Rezoning Transportation Analysis

Petition Number: 2022-210

General Location Identifier: 14506122, 14506121, 14506128, 14506120, 14606126

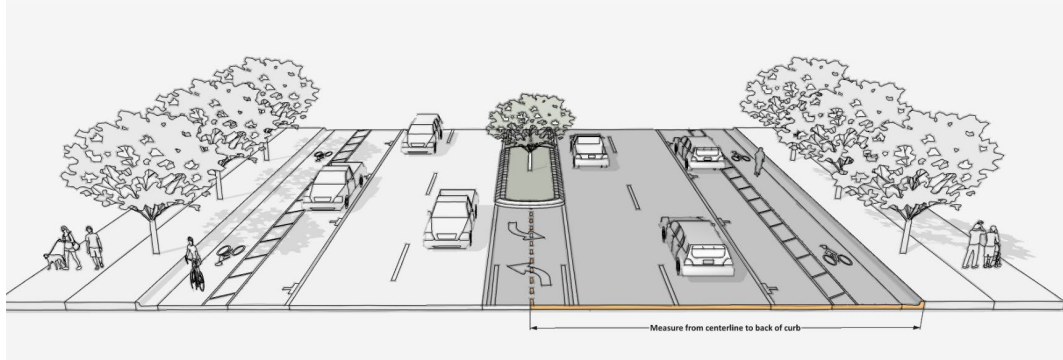
1. ~~Curbline:~~

- a. ~~South Tryon Street: Location of curb and gutter to be moved a minimum of 42.5 feet from roadway centerline to accommodate the Charlotte Streets Map with a roadway typical section of a 4+ Avenue with Buffered/Separated Bike Lanes and On-Street Parking.~~

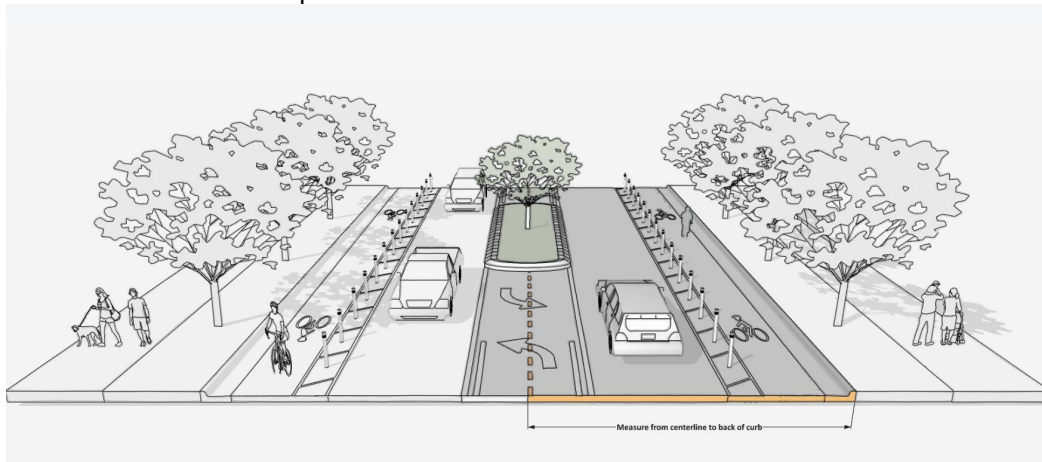
- b. ~~Clanton Road: Location of curb and gutter to be moved a minimum of 27 feet from roadway centerline to accommodate the Charlotte Streets Map with a roadway typical section of a 2+ Avenue with Buffered/Separated Bike Lanes.~~

NOTE: Additional distance from center line to back of curb may be required in locations where a median and turn lanes are required. Final curblines to be reviewed by CDOT once TIS is approved.

Outstanding Comment 9.20.23: ~~Label and dimension the curb and gutter from the centerline for each road on the site plan.~~

Clarifying comment 6.21.23: ~~Label and dimension the curb and gutter from the centerline for Clanton Road and South Tryon Street.~~
